STAFF RECOMMENDATION
927 South Douglas Avenue
December 21, 2016

Application: Demolition—primary Structure; New construction—infill
District: Waverly-Belmont Neighborhood Conservation Zoning Overlay
Council District: 07
Map and Parcel Number: 10513028100
Applicant: Manuel Zeitlin
Project Lead: Melissa Baldock, melissa.baldock@nashville.gov

Description of Project: Application is to demolish the existing non-contributing structure on the lot and to construct new duplex infill in its place.

1 Site Plan & Layout
1" = 20'-0"

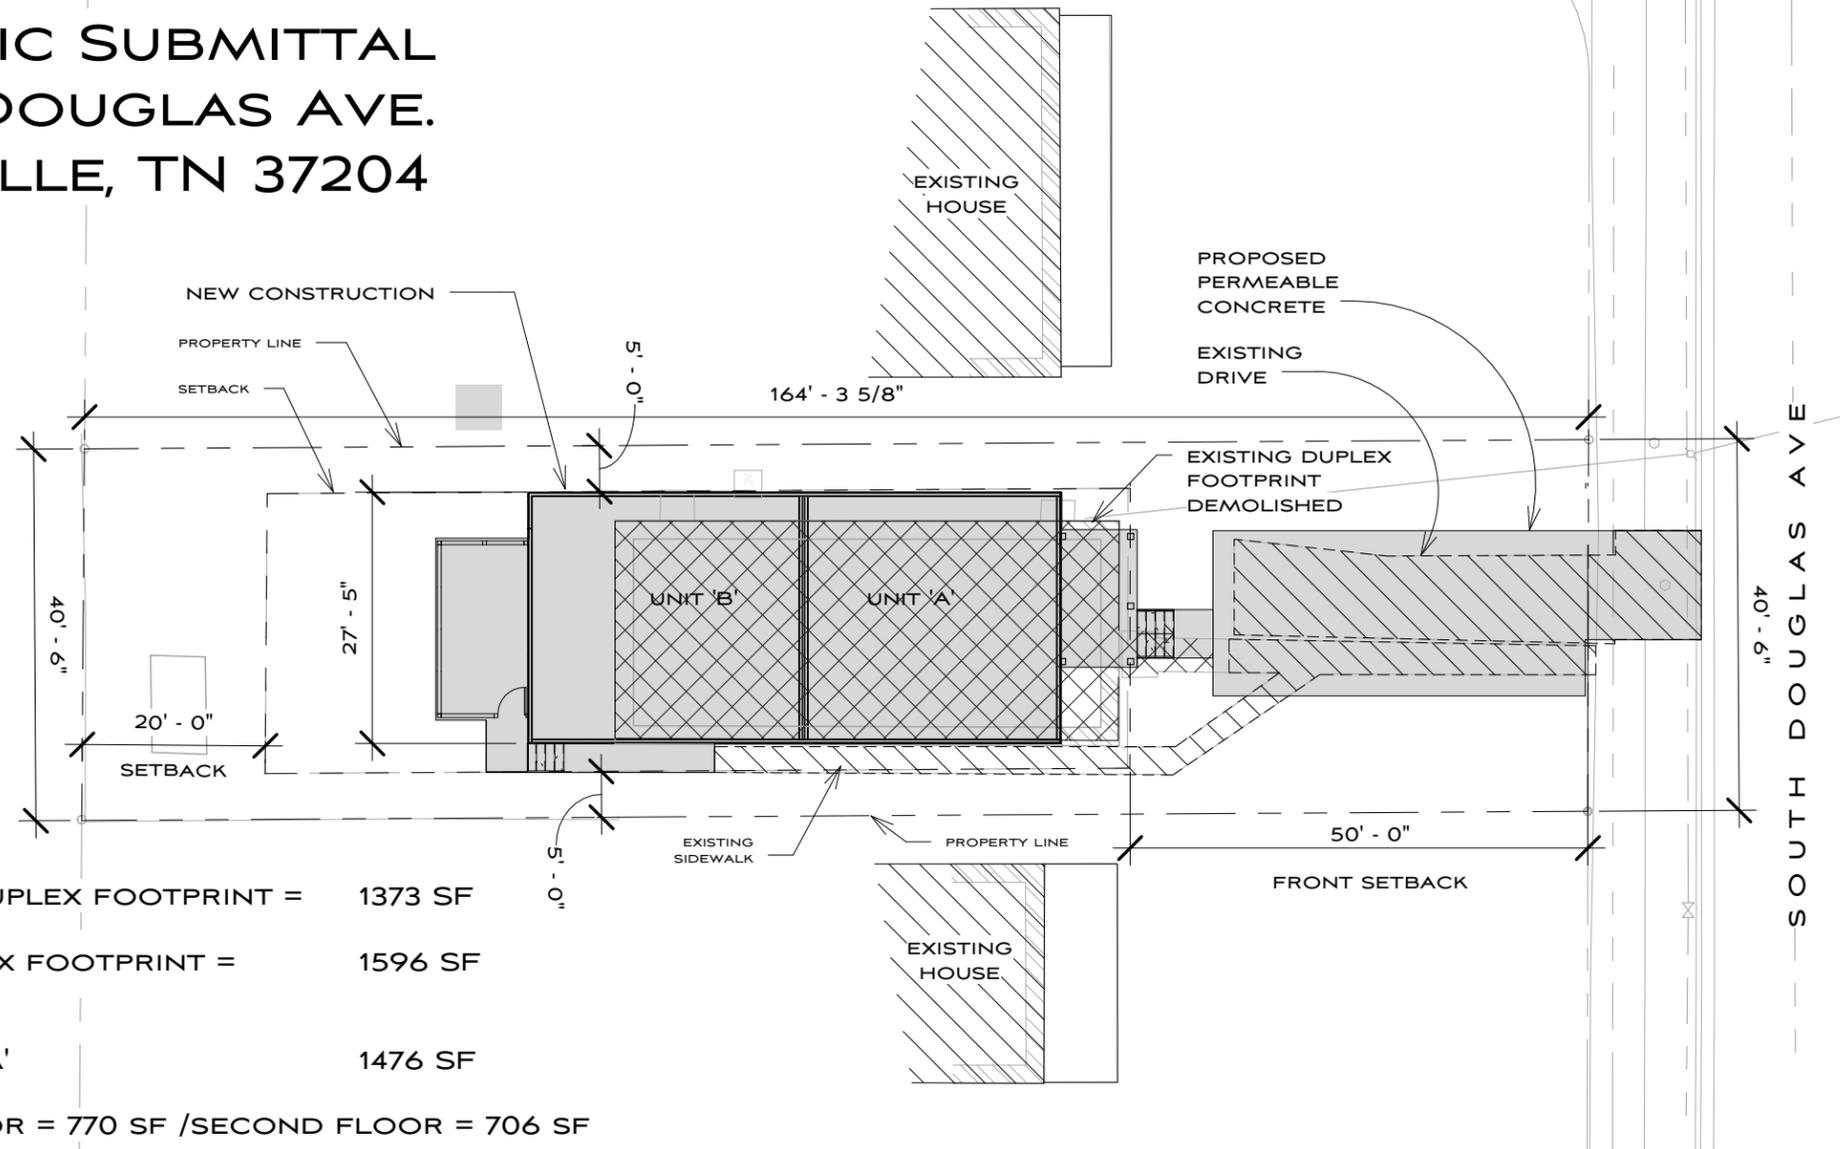
The site lacks an alley, and because of the narrowness of the lot, a driveway that extends to the side of the structure is not practical. There is existing front yard parking, and the applicant is seeking to expand the parking area (Figure 2). The existing parking area is approximately five hundred and two square feet (502 sq. ft.). The applicant is asking to

expand the parking area so that is approximately eight hundred and ninety square feet (890 sq. ft.). The drawings show that the new front yard parking will be permeable concrete, although the applicant has indicated that he would consider concrete pavers.

Front yard parking does not typically meet the design guidelines, as historically, parking was located at the rear of the house. However, the lot's narrowness and lack of an alley constrain the location of on-site parking. Staff recommends working with the applicant to find a material that will best minimize the visual impact of the front yard parking. With this condition, staff finds that the project's orientation meets Sections III.F. and IV. of the design guidelines.

1 Demolition - Existing Duplex
 1/8" = 1'-0"

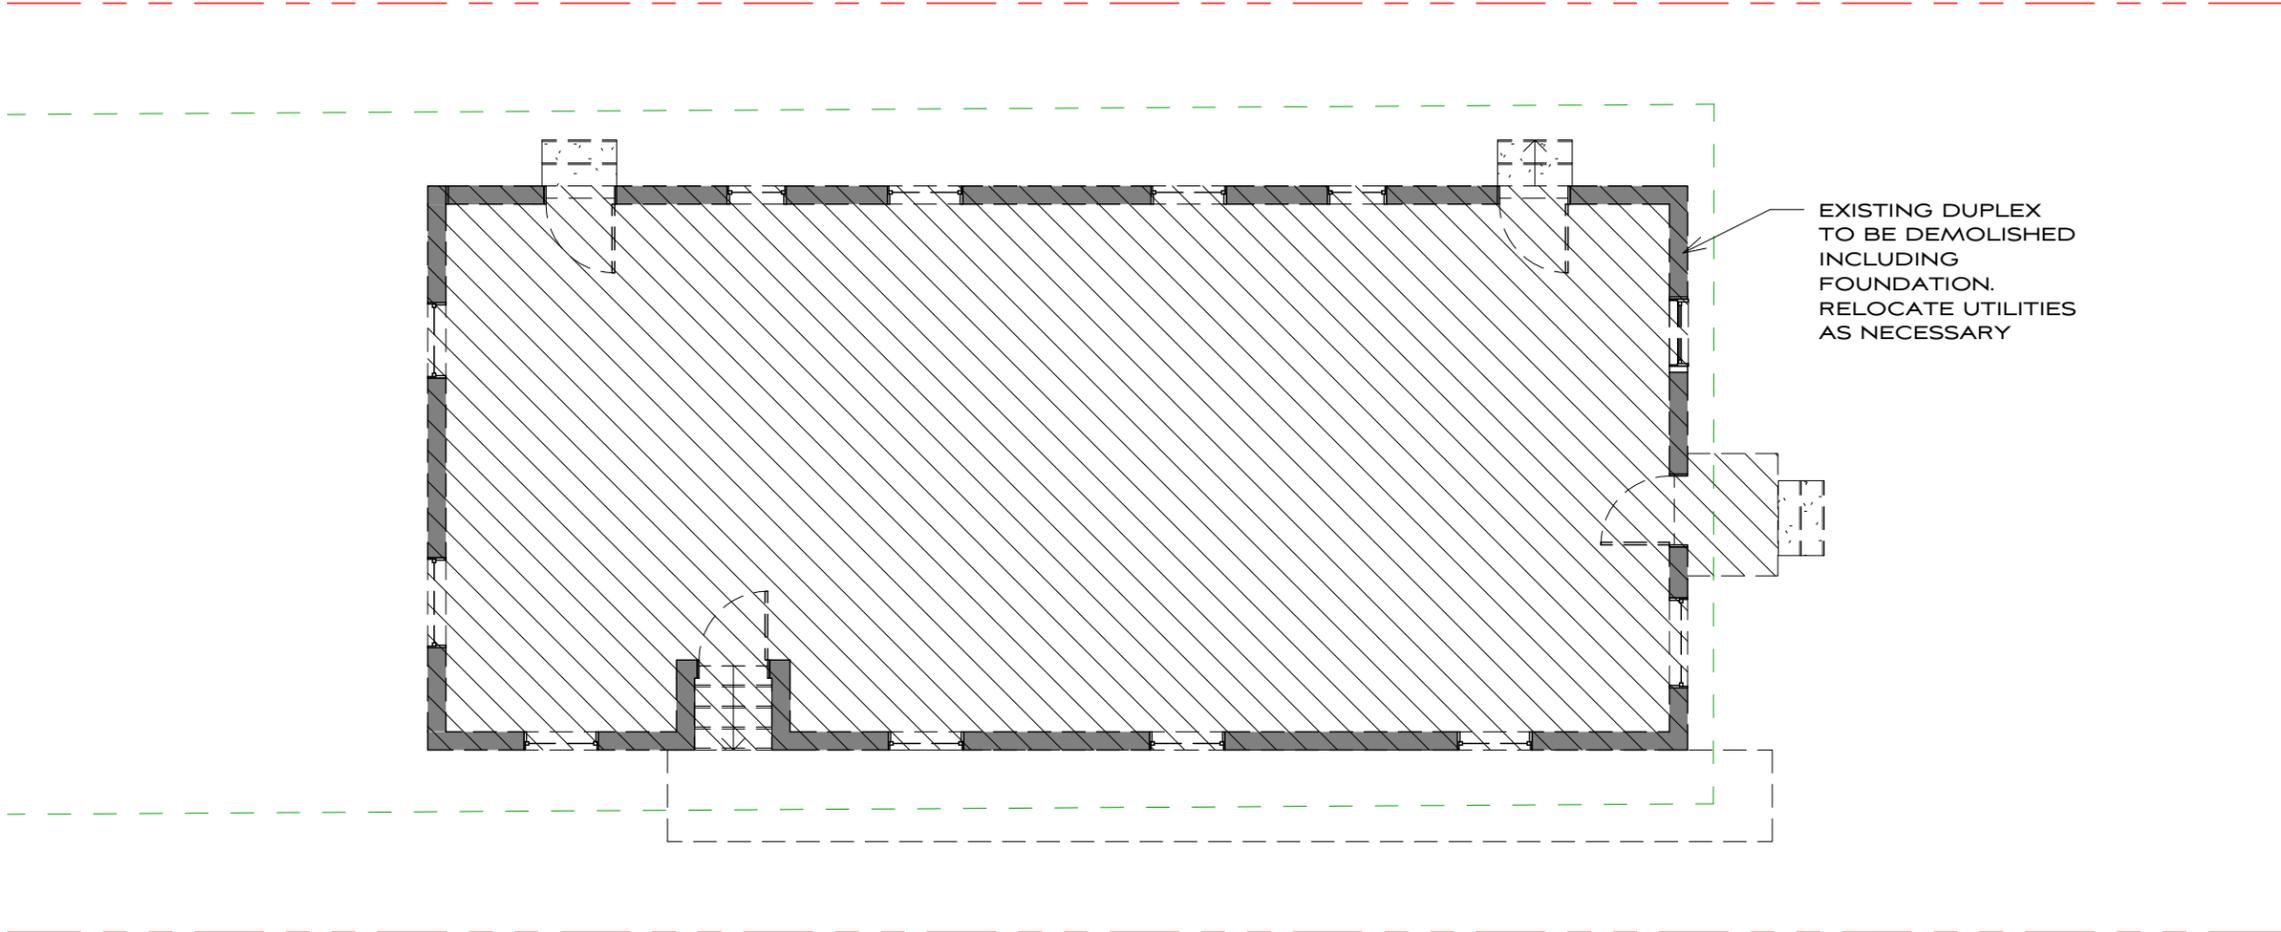
Demolition: The existing structure on the lot was constructed c. 1959, later than the period of significance for the Waverly-Belmont neighborhood conservation zoning overlay. Its roof form, fenestration pattern, materials, and detailing do not contribute to the historic character of the neighborhood. Staff therefore finds that the proposed demolition meets Section V.B.2 for appropriate demolition and does not meet section V.B.1 for inappropriate demolition.

ELEVATIONS

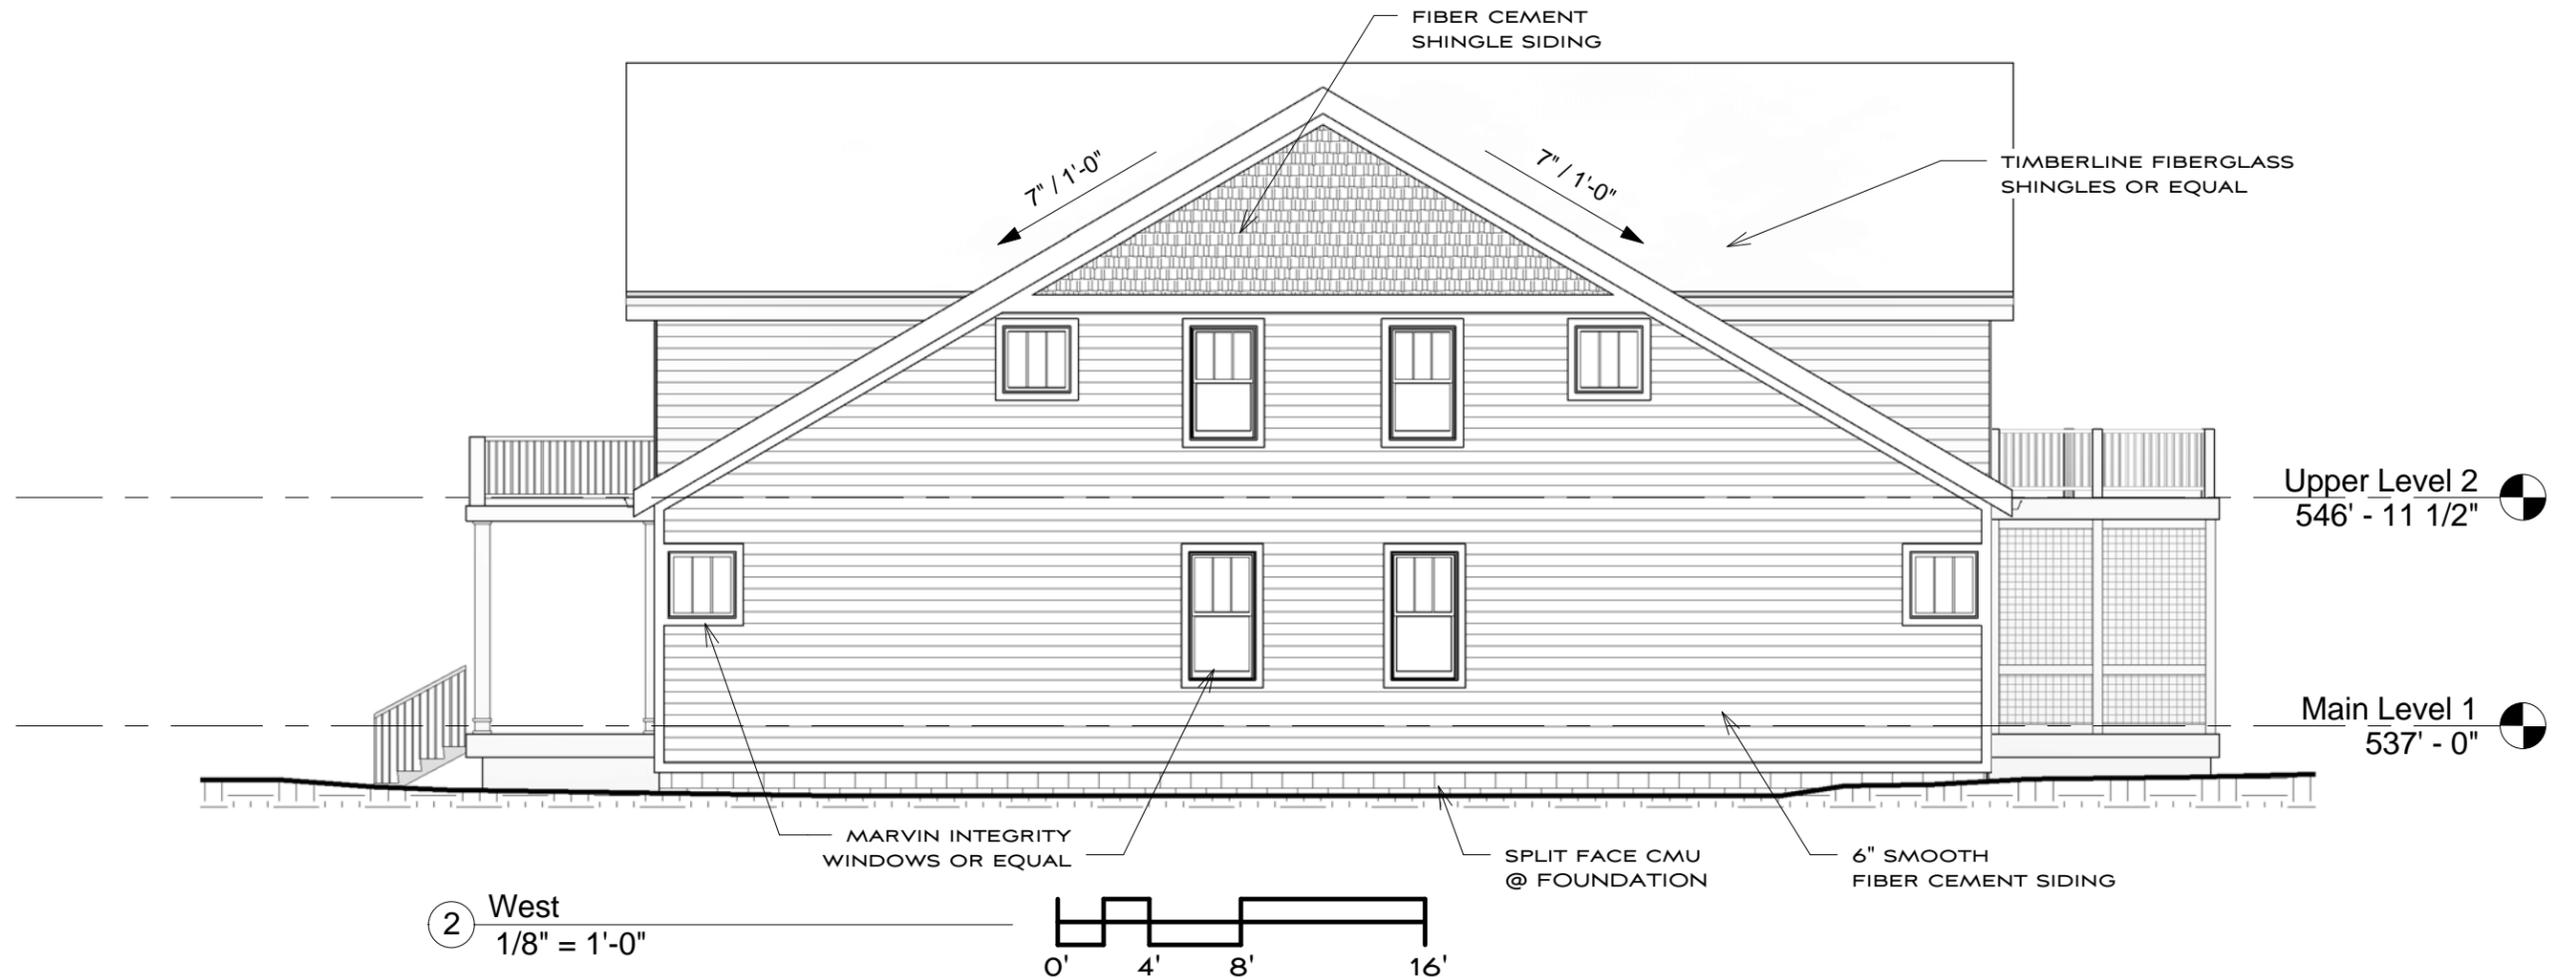
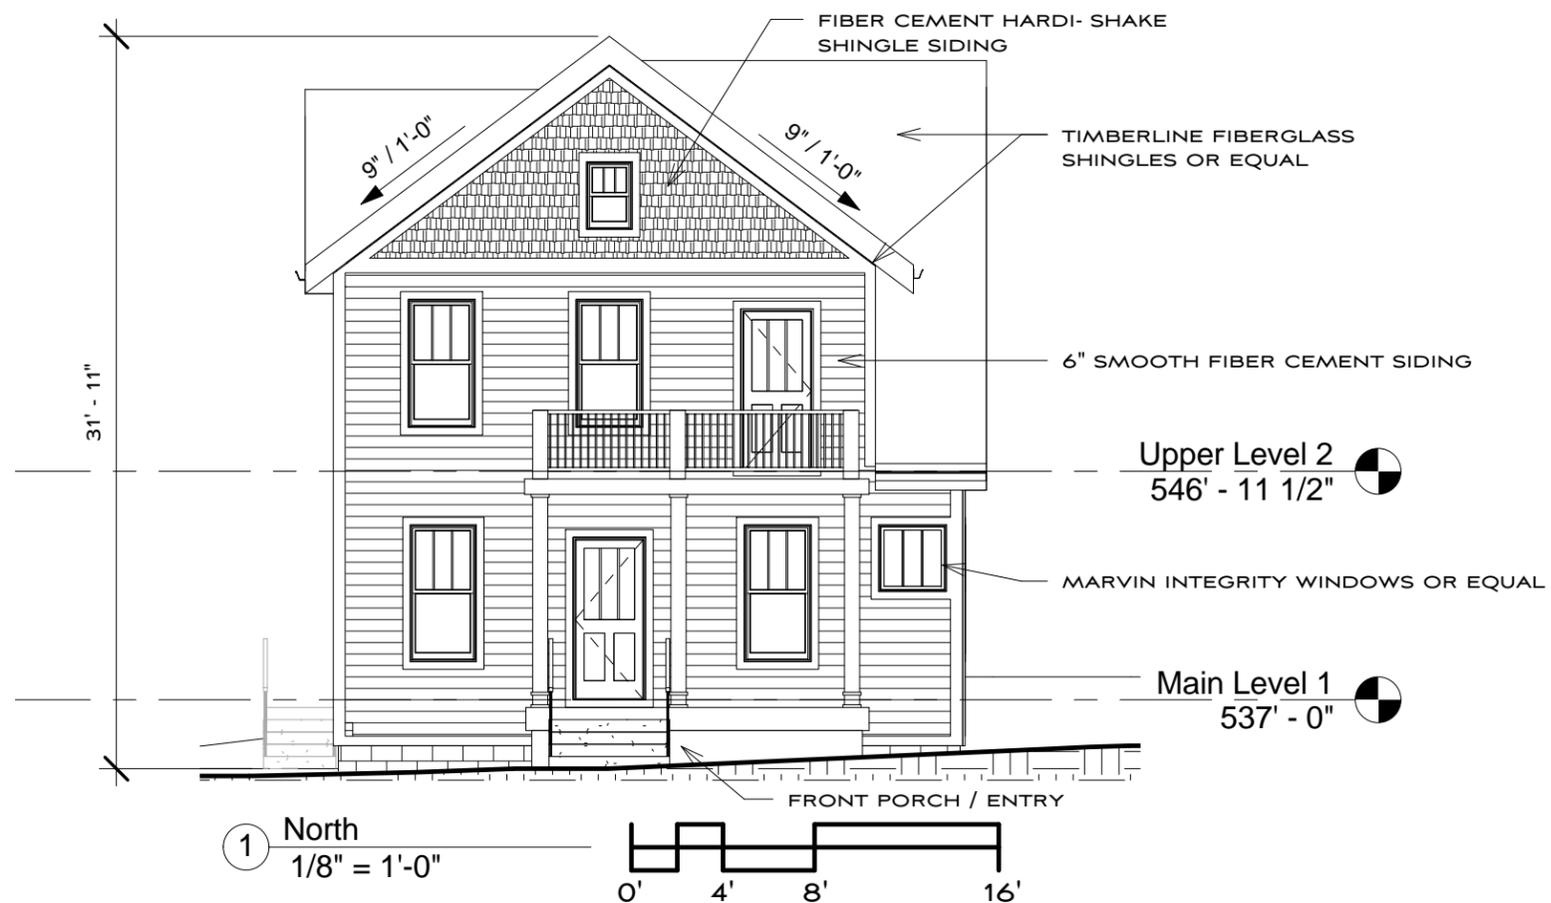
Height & Scale: The new infill is proposed to be two stories, which staff finds to be appropriate because the house is flanked by larger, non-contributing structures, and there is little historic context in the immediate vicinity. The infill will have an eave height of approximately twenty-one feet (21') and a ridge height of thirty-one feet, eleven inches (31'11") from grade. Staff finds that this meets the overall historic context where structures range in height from twenty-one to thirty six feet (21'-36').

Roof form: The infill's primary roof form is a cross gable. The front-facing gable will have a slope of 9/12. The side gable will have a slope of 7/12. The front porch roof will be flat and will have an uncovered balcony on top of it. Staff finds the balcony to be appropriate because it is uncovered and because there is little historic context in the immediate vicinity. The rear porch will also be flat with an uncovered second story balcony. Staff finds that the project's roof form meets Section III.E. of the design guidelines.

Proportion and Rhythm of Openings: The windows on the proposed infill are all generally twice as tall as they are wide, thereby meeting the historic proportions of openings. There are no large expanses of wall space without a window or door opening. Staff finds the project's proportion and rhythm of openings to meet Section III.G. of the design guidelines.

Staff recommends that the siding reveal be a maximum of five inches (5"). Staff also recommends approval of the roof shingle color and texture, all doors, the side step railing, and the driveway and walkway material prior to purchase and installation. With these conditions, staff finds that the project's known materials meet Section III.D. of the design guidelines.
